Product/Process Change Notice (PCN)

PCN #: ConUSB_20151030
 Product Affected: 629004113921 & 629104113921
 PCN Date: November 13th, 2015
 Effective Date: February 1st, 2016
 Contact: Product Management
 Tel: +49 7942 945-5001
 Fax: +49 7942 945-5179
 E-mail: PCN.eican@we-online.de

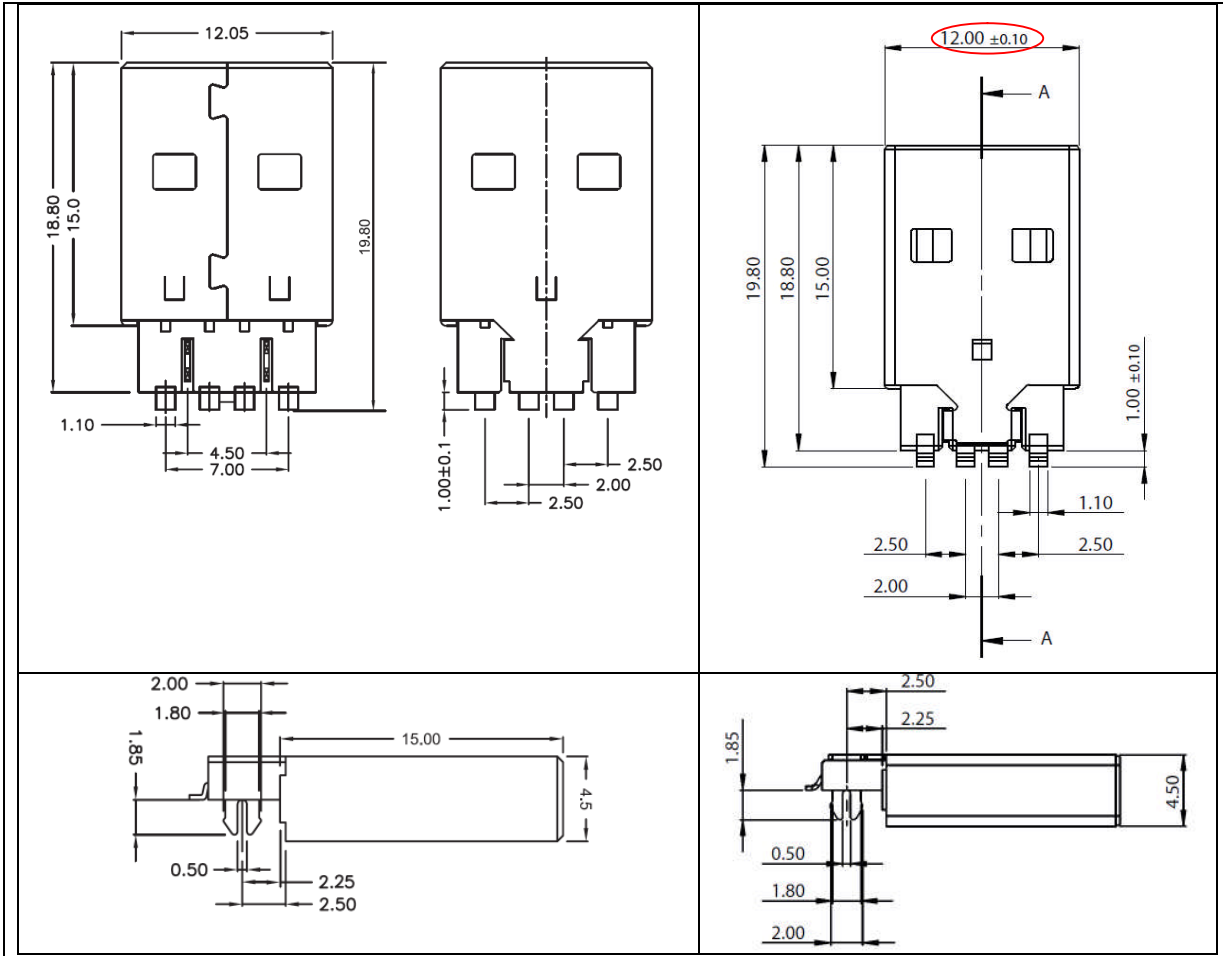
A fully automatized process will be implemented and CCD inspection controls will be added. The design changes are summarized below and marked in red:
